ADDENDUM NO: 01

PROJECT: Center Grove MS Central Renovation

PROJECT NO: 2024017 DATE: June 25, 2025 BY: Jack Leibham

DRAWING NUMBER A800

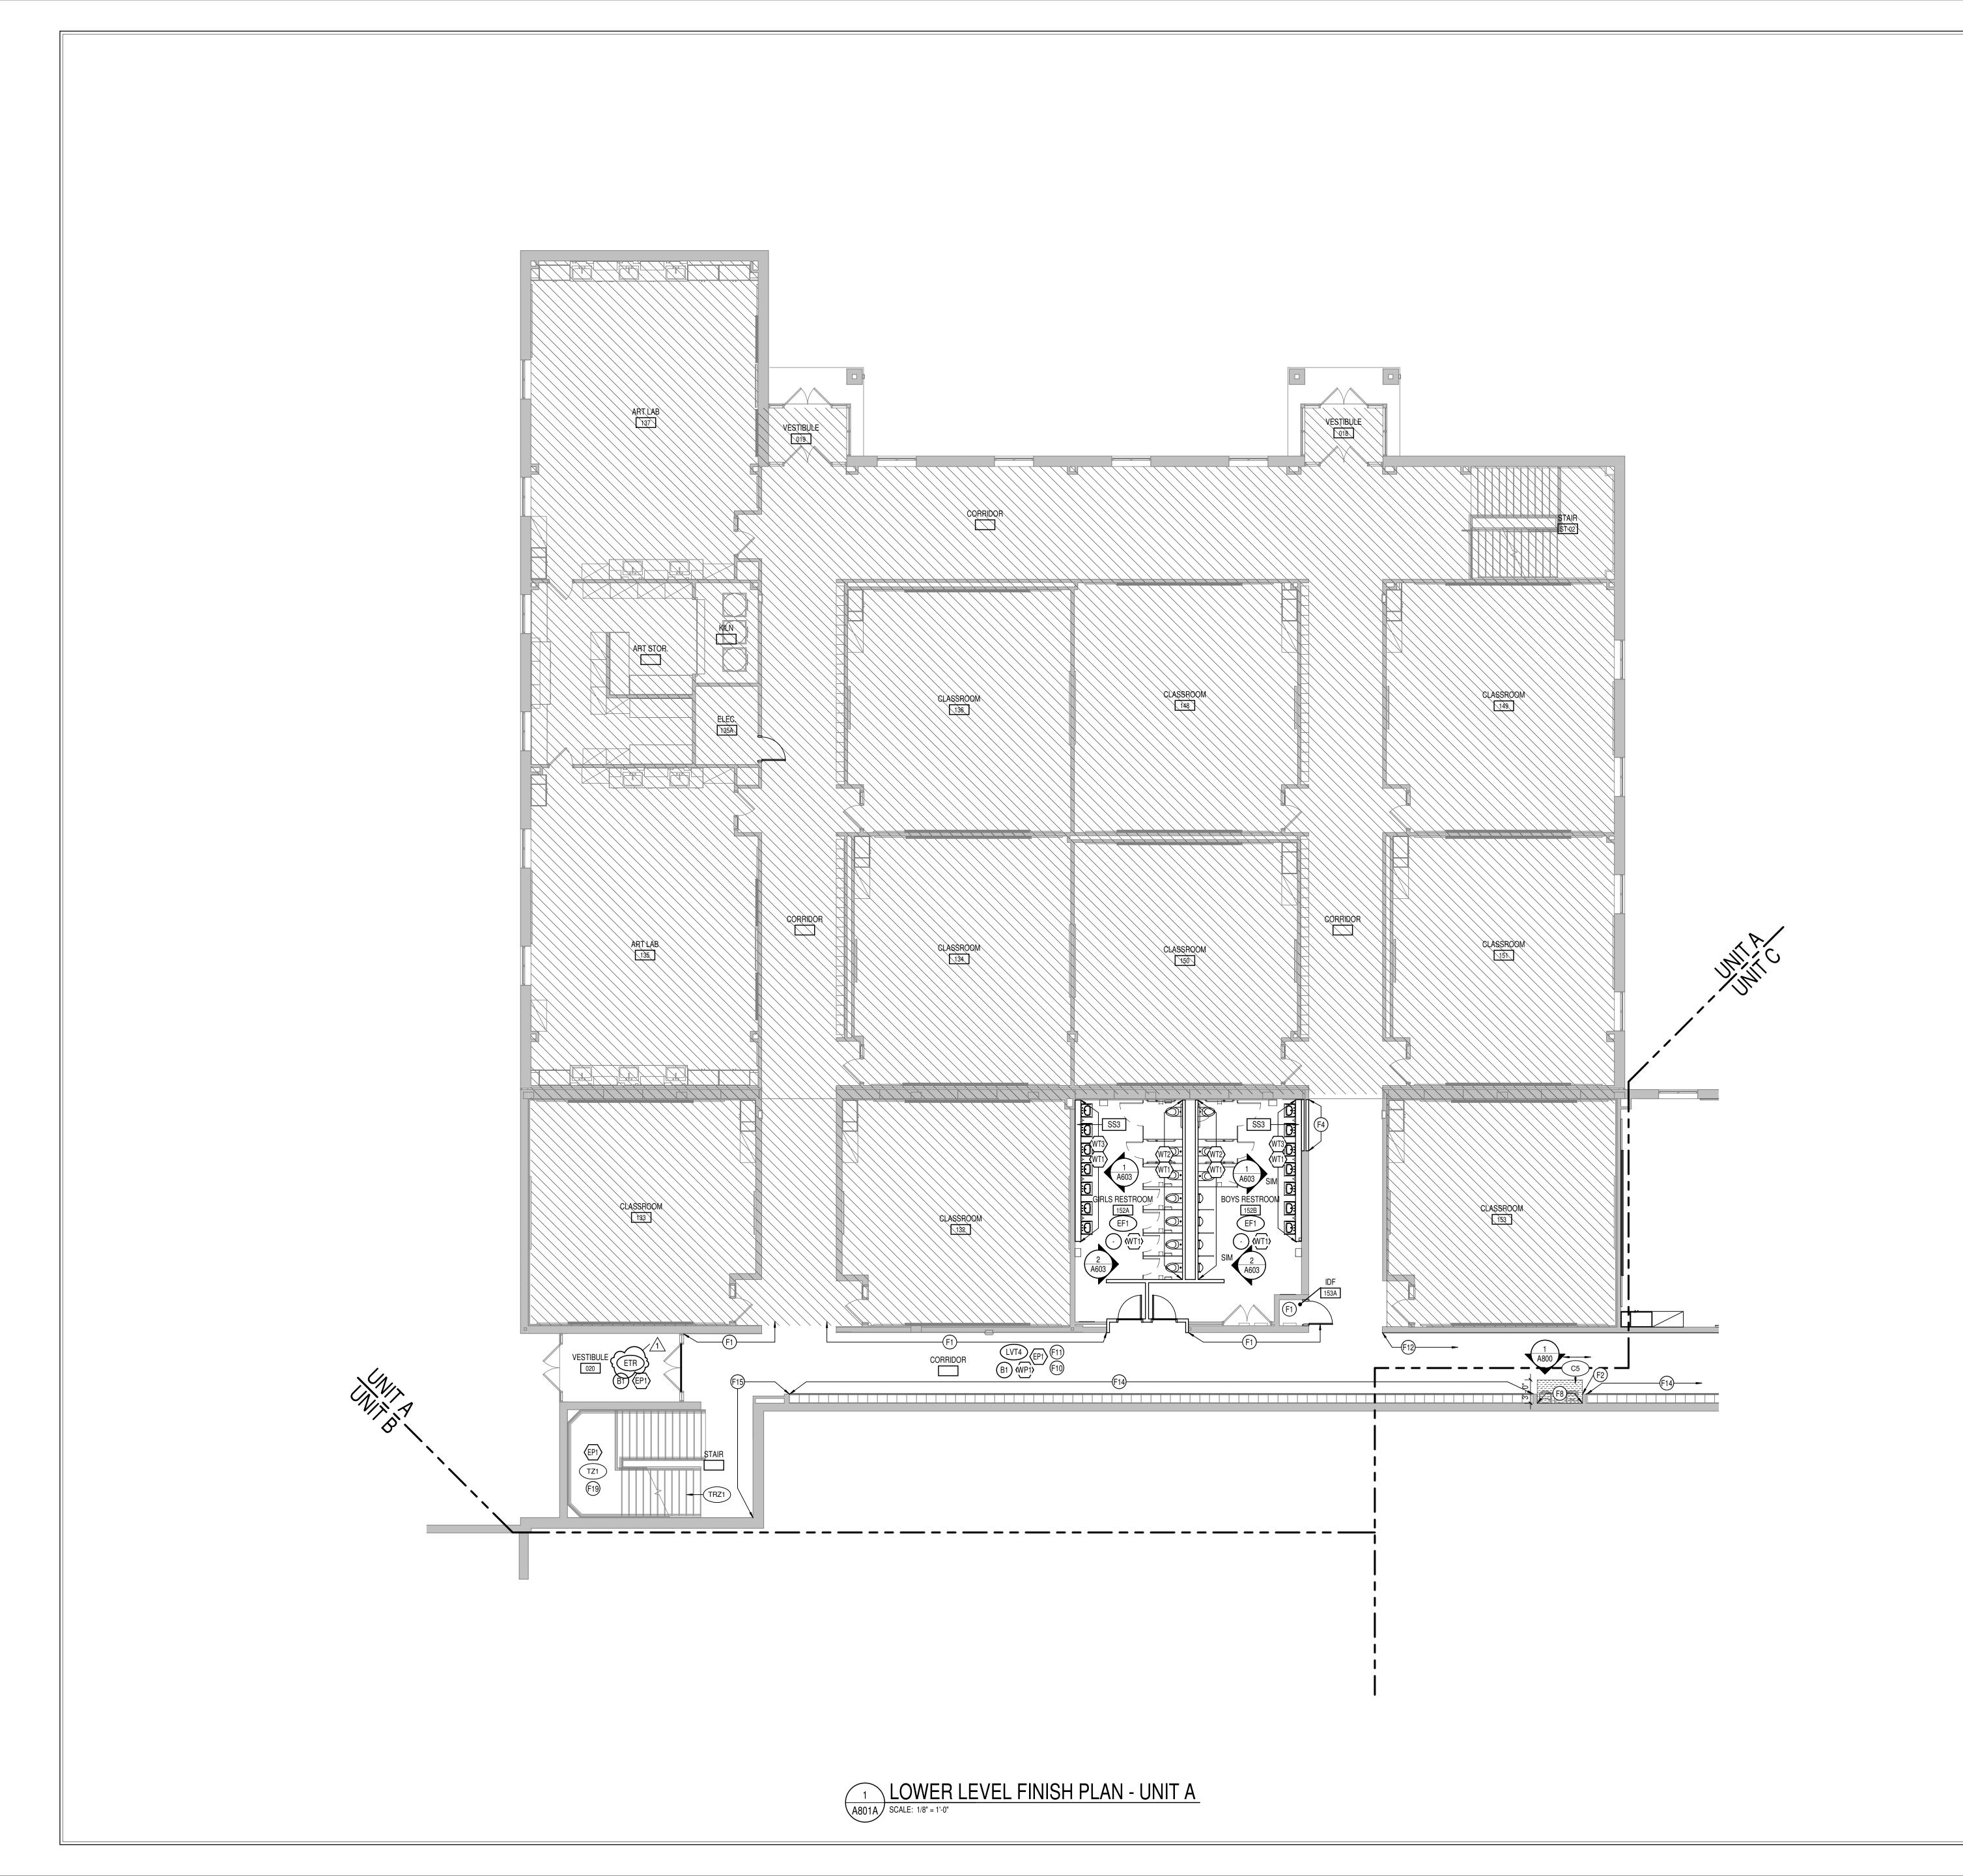
- A. Revise transitions as indicated.
- B. Revise RF1 and TR1 and as indicated.
- C. Add B2

DRAWING NUMBER
A801A

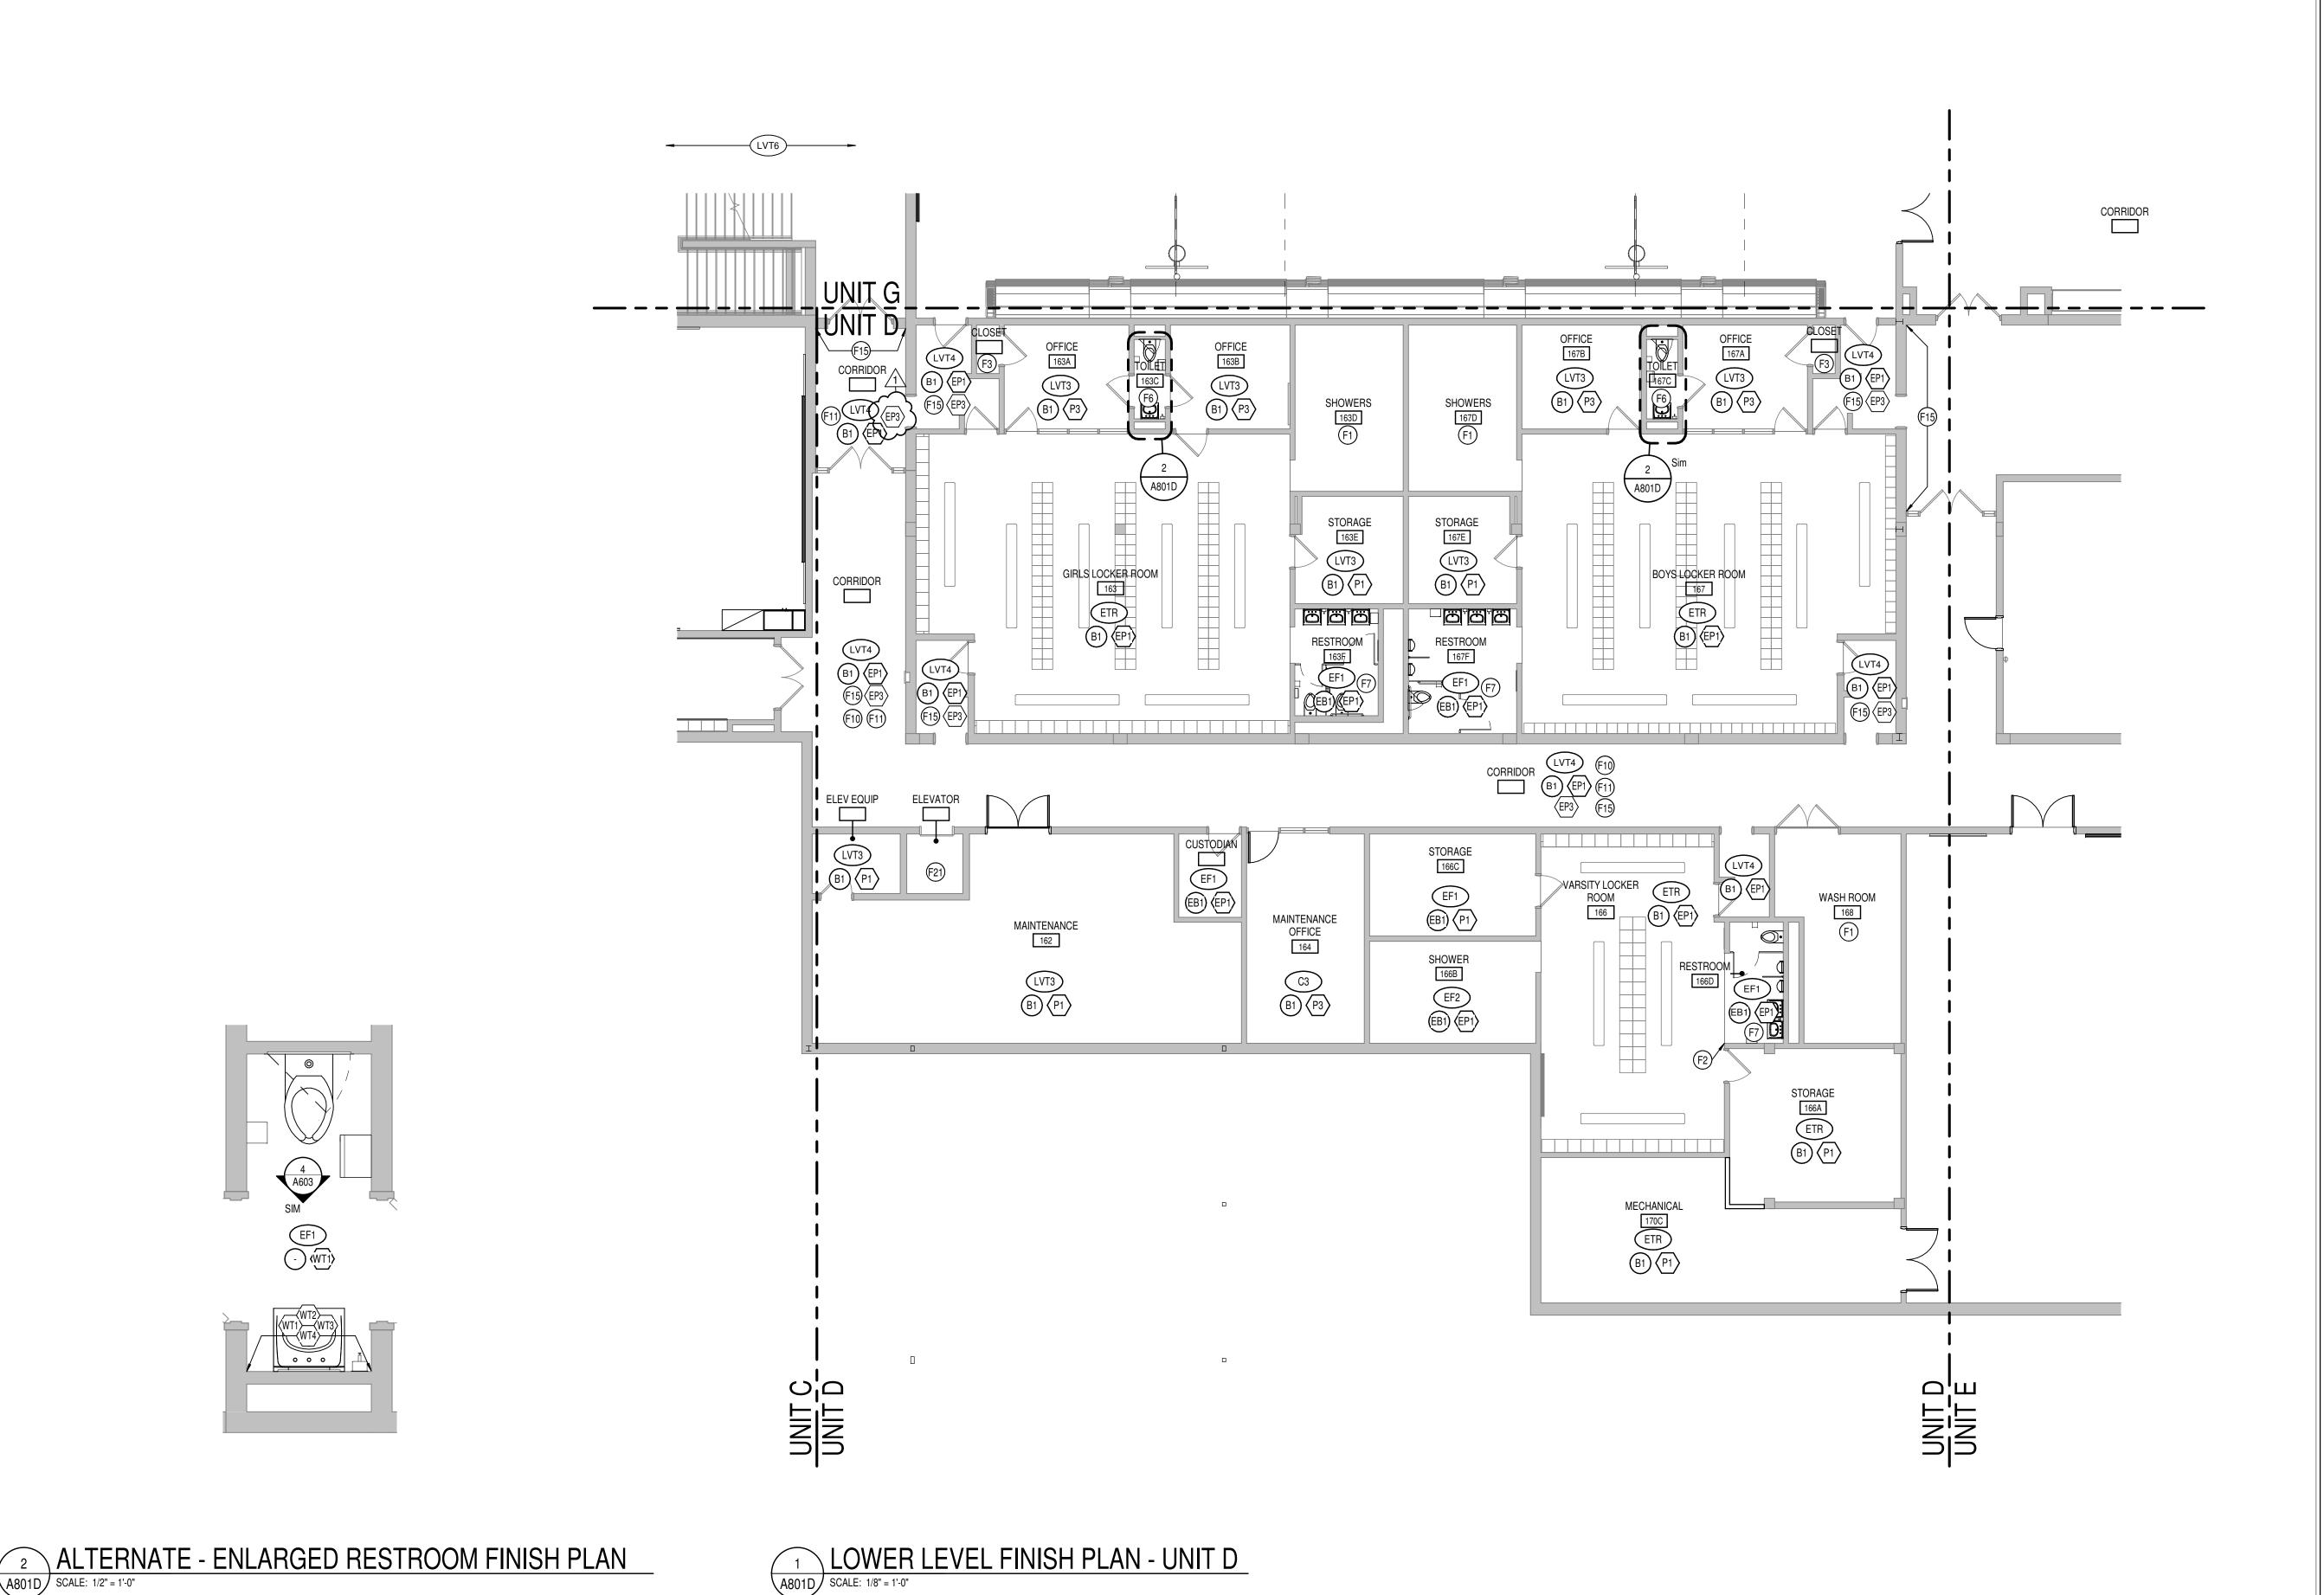
A. Revise WOC to **ETR** in vestibule as indicated.

DRAWING NUMBER A801D PROJECT NUMBER 2024017

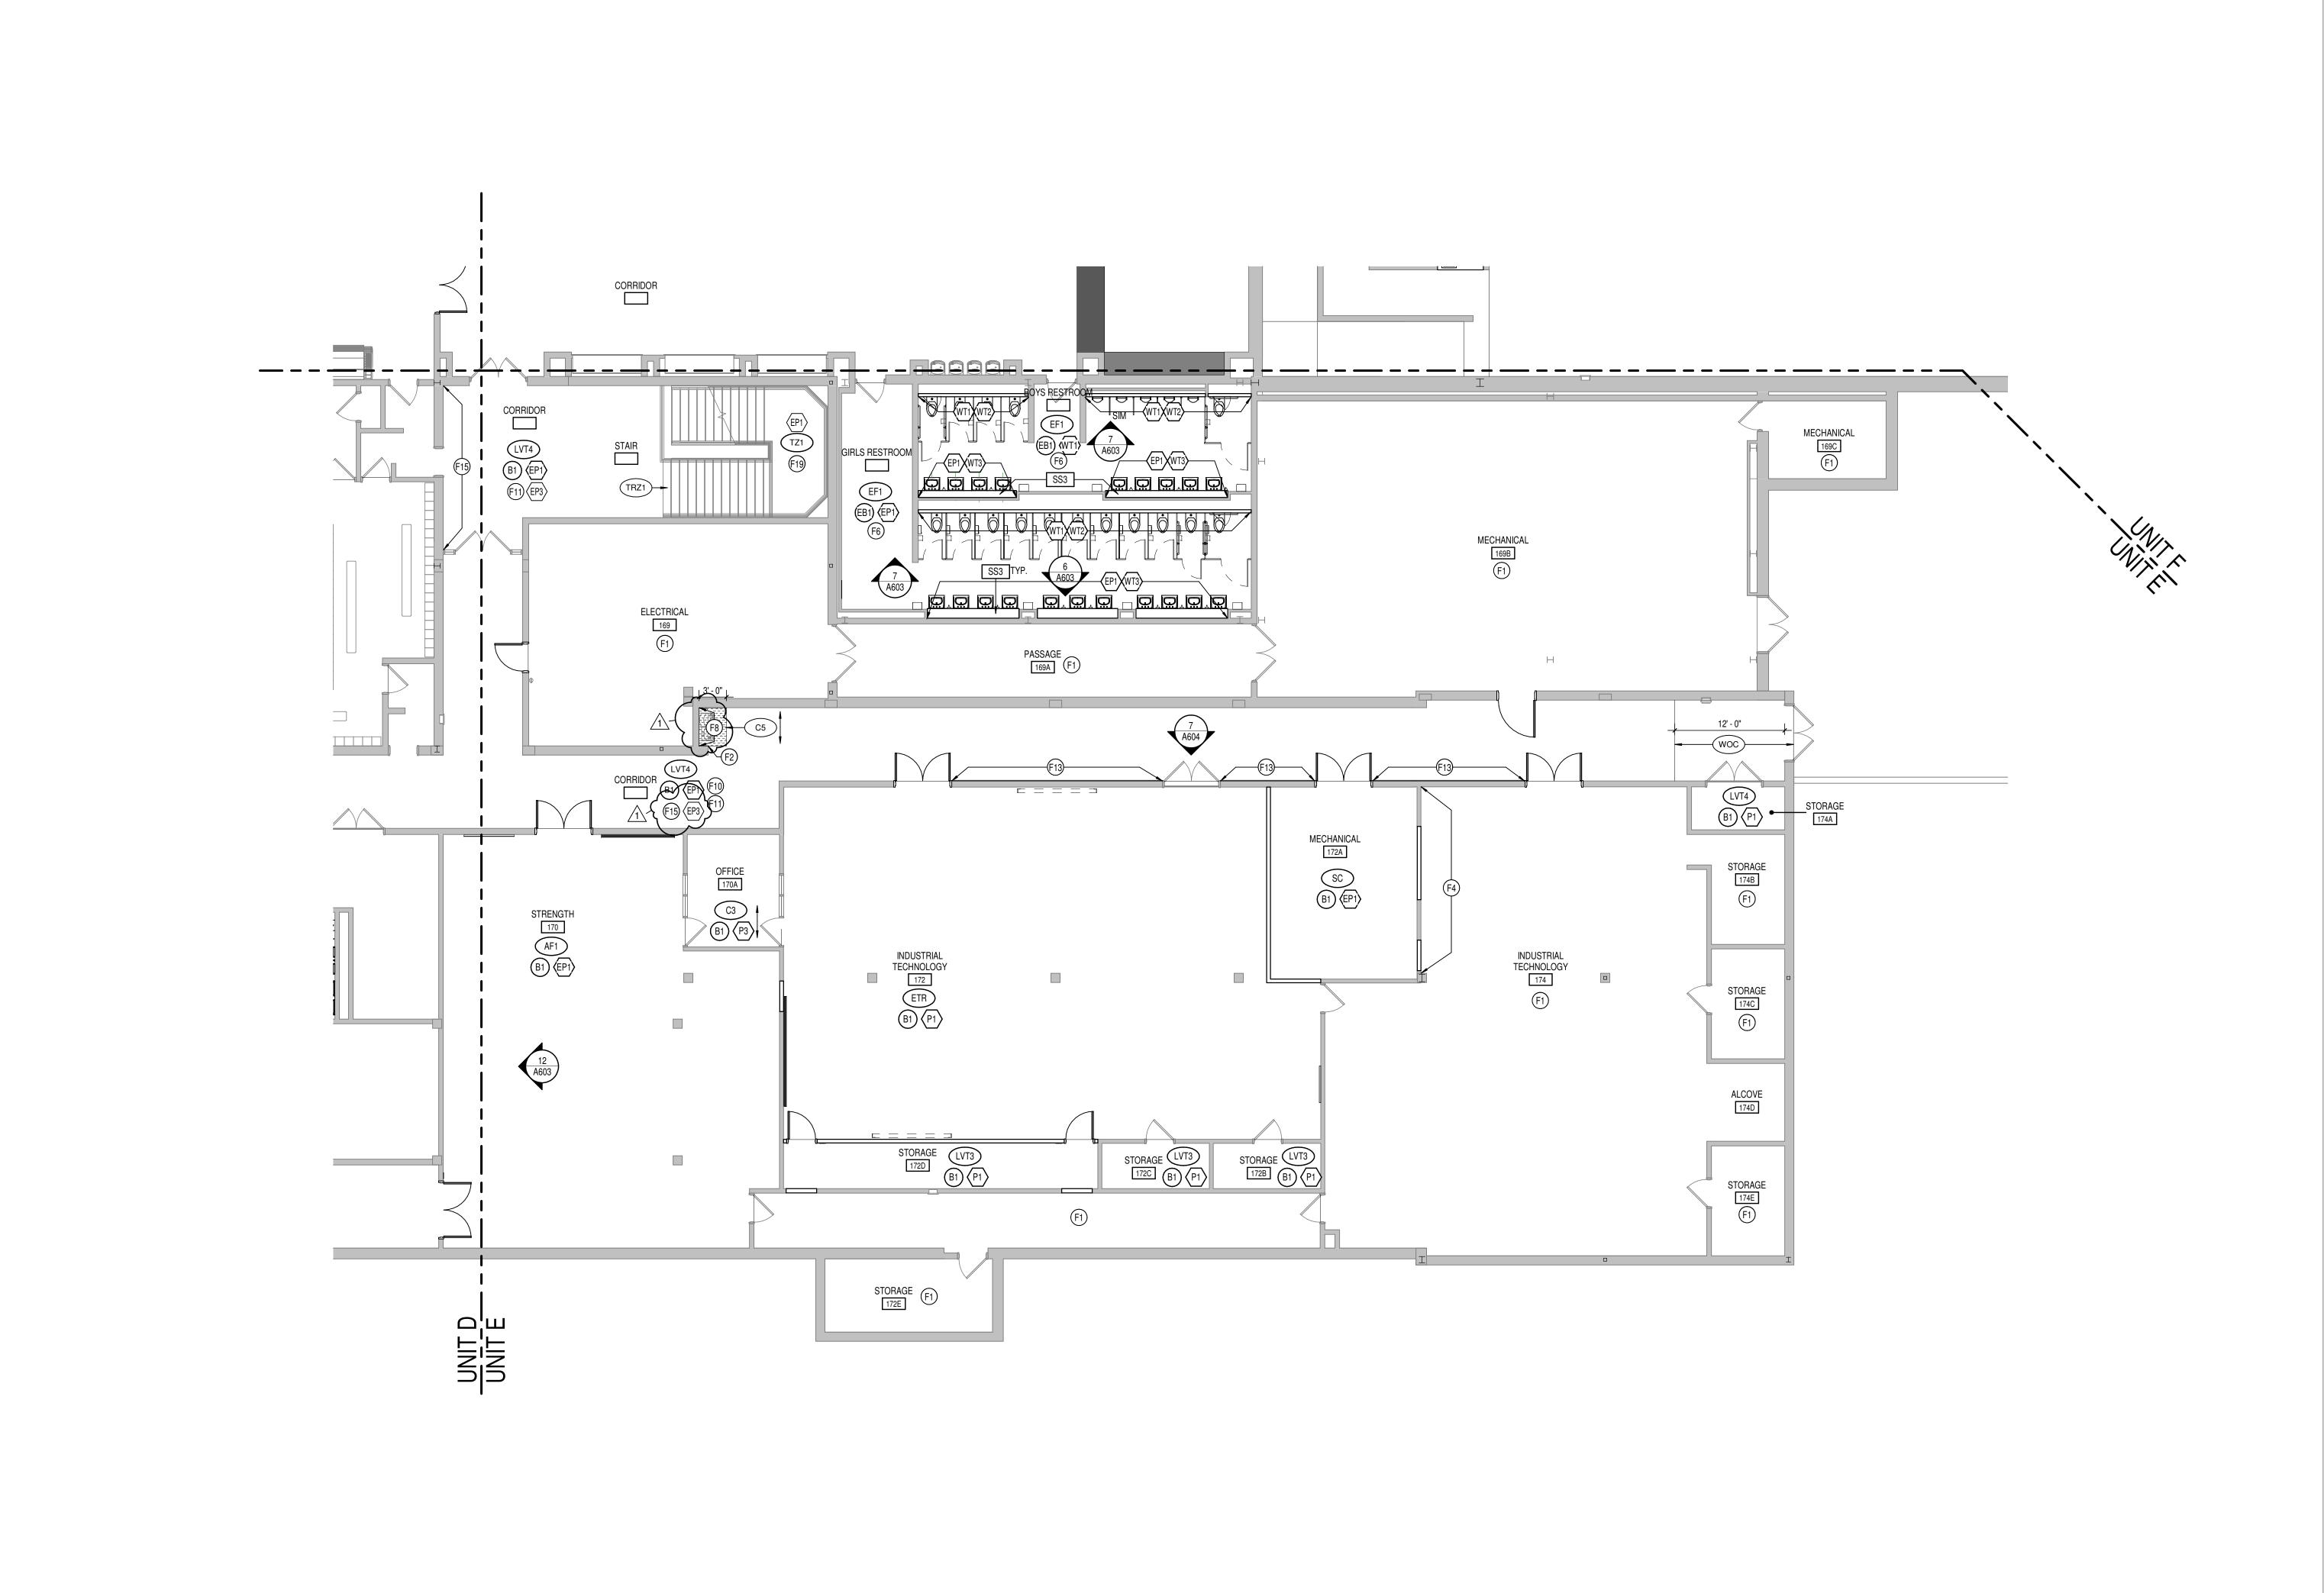
A. Add EP3 tag as indicated.
